## 1 Document control

FRNSW reference number FRN17/753

Premises name	The Department of Lands Building
Primary street address	23-39 Bridge Street (Sandstone Precinct)
Secondary street address	23 – 33 Bridge Street (Lands Building)
Premises suburb	Sydney
Lot and DP numbers	1877/-/DP877000 (Lands Building), 56/-/DP729620 (Education Building)

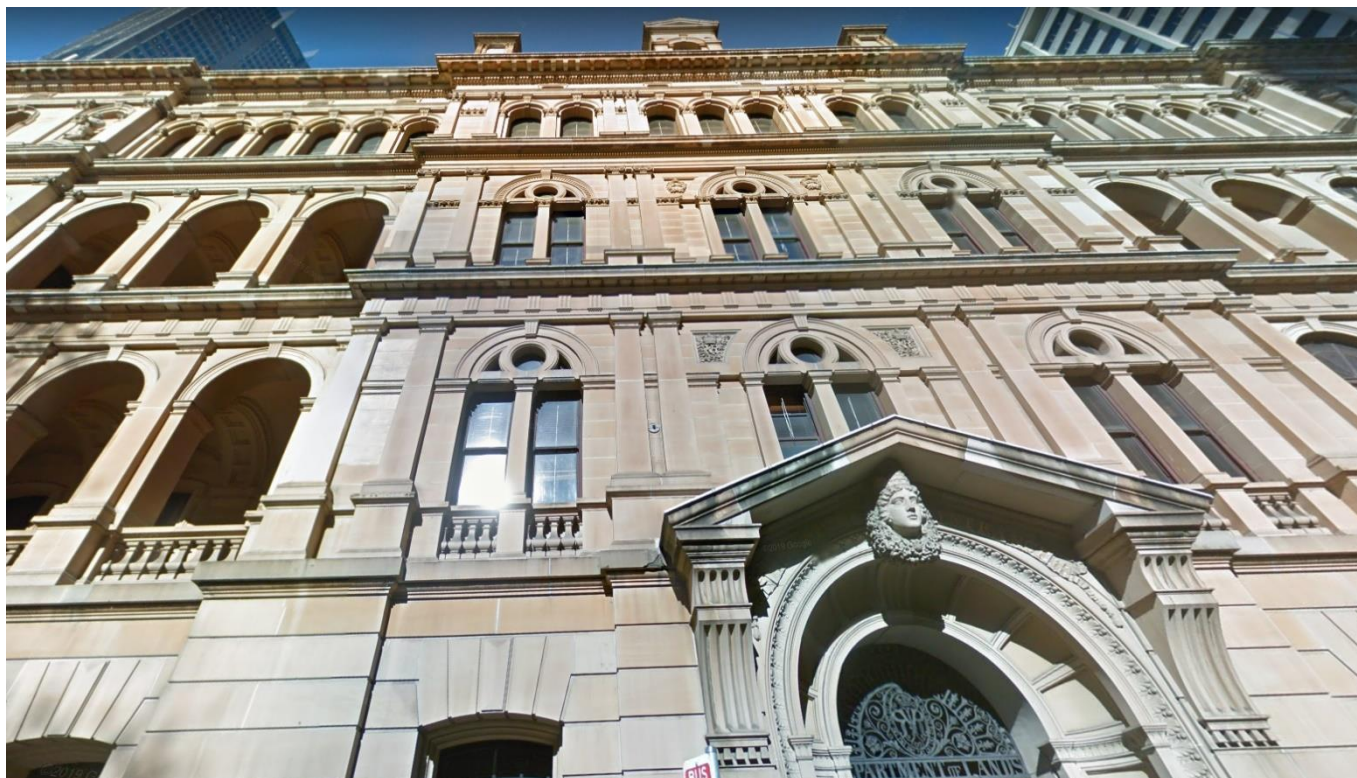
- It is recommended that additional details be provided regarding the abovementioned “Other” hazard that has been selected, no information has been provided.
- It is noted that the performance solution related to Issue Number 2 within this FEBQ refers to the use of combustible materials on the façade of the development, however the above hazard has not been selected. This is to be addressed.

WGE: Hazards updated to include combustible façade elements.

FRNSW Comment: Noted, refer to the comments provided by FRNSW on Issue Number 2 of this FEBQ.

Figure 1: Basement 3 detection requirements.

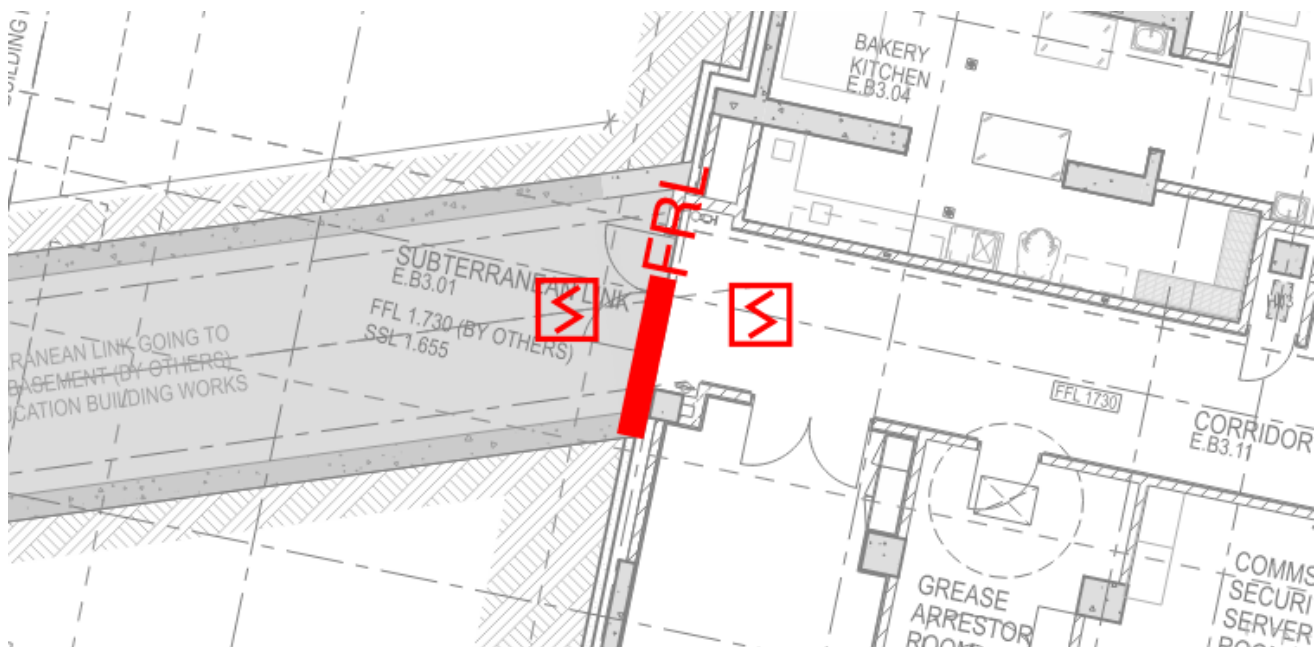
FRNSW Comment: Noted, the abovementioned provisions are recommended to be adequately detailed within the FER.

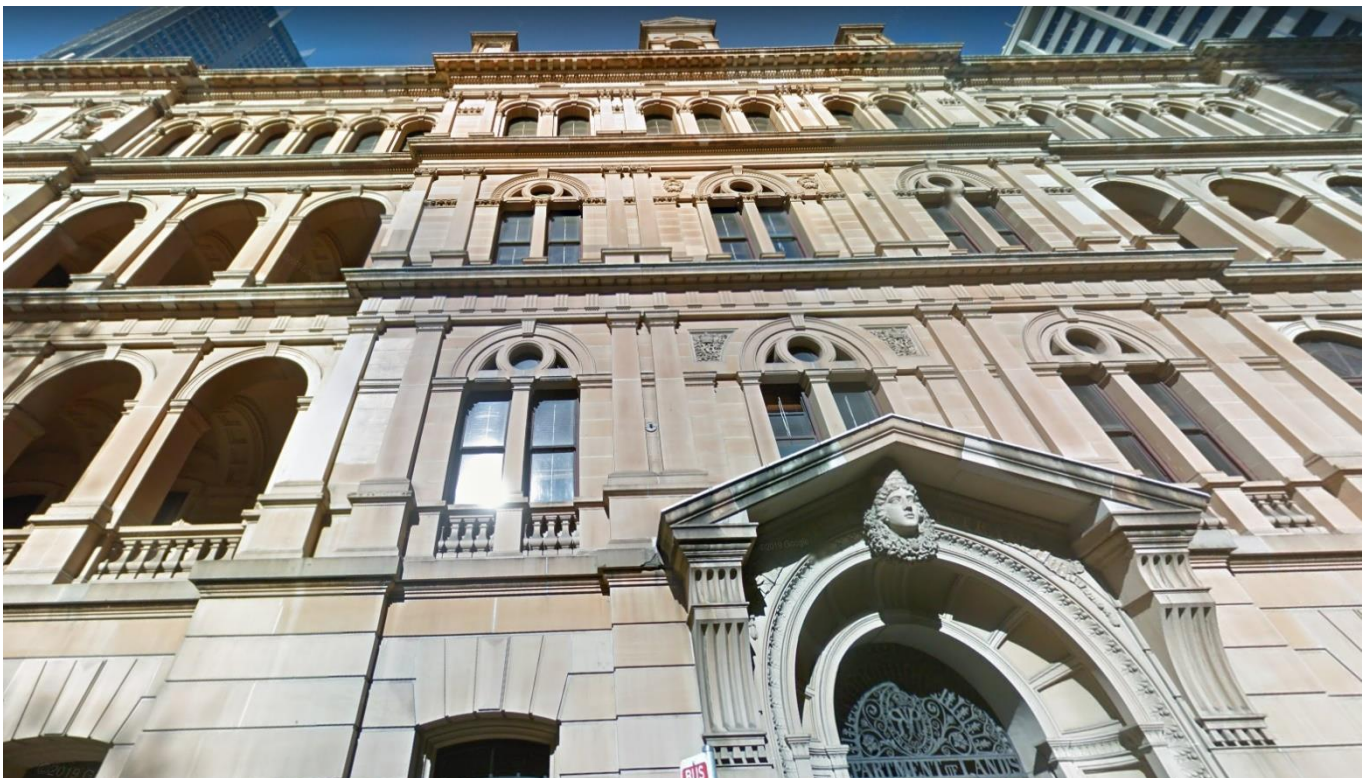
- Insufficient information is provided regarding the combustible timber elements, e.g. the locations and their fire hazard properties.
- FRNSW recommend pictorial representations be provided that highlight the regions in which the timber elements will be included. This will allow FRNSW to review the extent of coverage appropriately.
